METROPOLITAN GOVERNMENT OF NASHVILLE AND DAVIDSON COUNTY

STAFF RECOMMENDATION
3703 Richland Avenue
Lot 13, Richland Hall Development
April 18, 2018

Application: New construction—infill and outbuilding
District: Richland-West End Neighborhood Conservation Zoning Overlay
Council District: 24
Map and Parcel Number: 10409029300
Applicant: Chad Gore, Mike Ford Builders
Project Lead: Melissa Baldock, melissa.baldock@nashville.gov

Figure 1. 3703 Richland Avenue

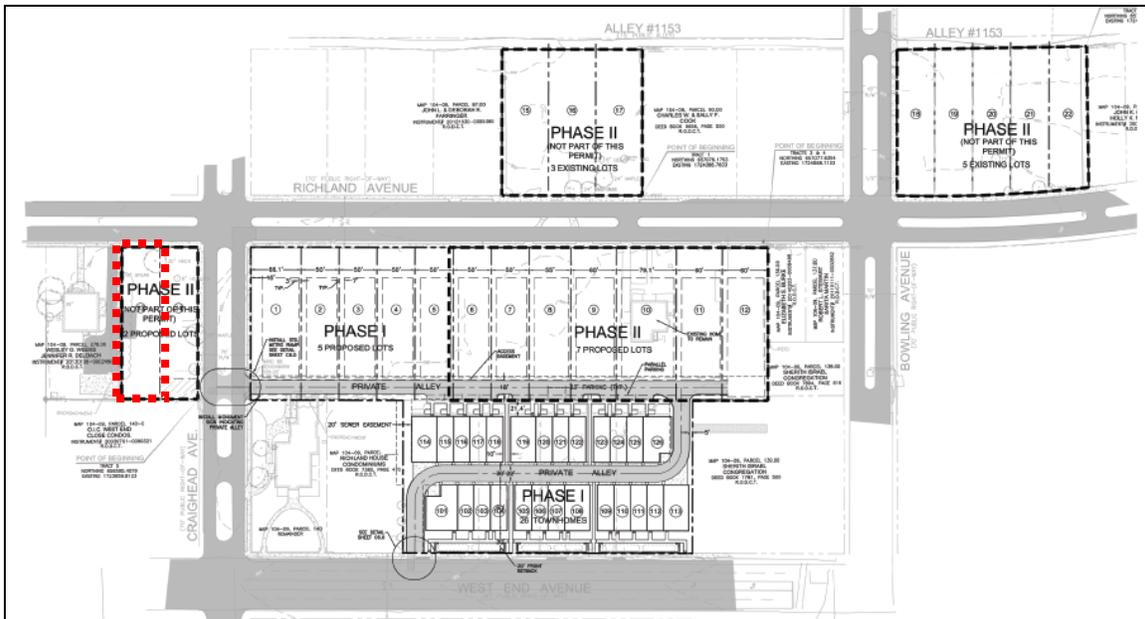
Background: 3703 Richland Avenue is a currently a vacant lot (Figure 1). Formerly on the site was a non-contributing building that was part of the Welch College (formerly the Free Will Baptist Bible College) campus. The College has moved to a new location and the building has been demolished. The new owner of the college's property plans 22 new infill houses within the Richland-West Neighborhood Conservation Zoning Overlay (Figure 2). (Figure 2). To date, MHZC has approved infill and outbuildings for 11 lots, including Lots 1, 2, 3, 4, 5, 6, 11, 12, 14, 15, 16, and 17 (3657, 3653, 3649, 3641, 3637, 3633, 3613, 3609, 3701, 3614, 3612, and 3610 Richland Avenue, respectively). Several of these houses have been constructed (See photos at end of document).
